Authorized Field Change

AFC G-01903

Subject: Replacement Rear Engine Mount Snubber Washer Used on 4300 and 4400 Models with VIN Numbers before 2H411832 Built Between October 24, 2000 and March 21, 2001

Figure 1 Arrows Indicate Nut and Snubber Washer

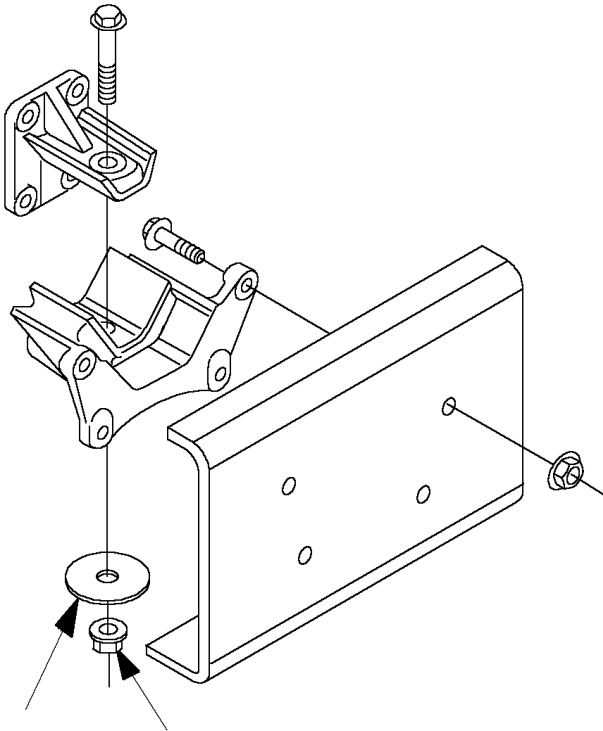
The rear engine mounts on 4300 and 4400 Models built between October 24, 2000 and March 21, 2001 have the wrong snubber washer installed. The integrity of the engine mount is maintained but the vehicle will exhibit greater mirror vibration at engine idle, floor vibration, increased low frequency interior noise levels and premature isolator wear.

1. Remove the engine rear mount nut and snubber washer (Figure 1). Retain the nut for reuse.
2. Install new snubber washer Part Number 3532955C1 and nut.
3. Tighten the engine rear mounting bolt to 217 to 240 Lbf-ft (294 to 325 Nm).
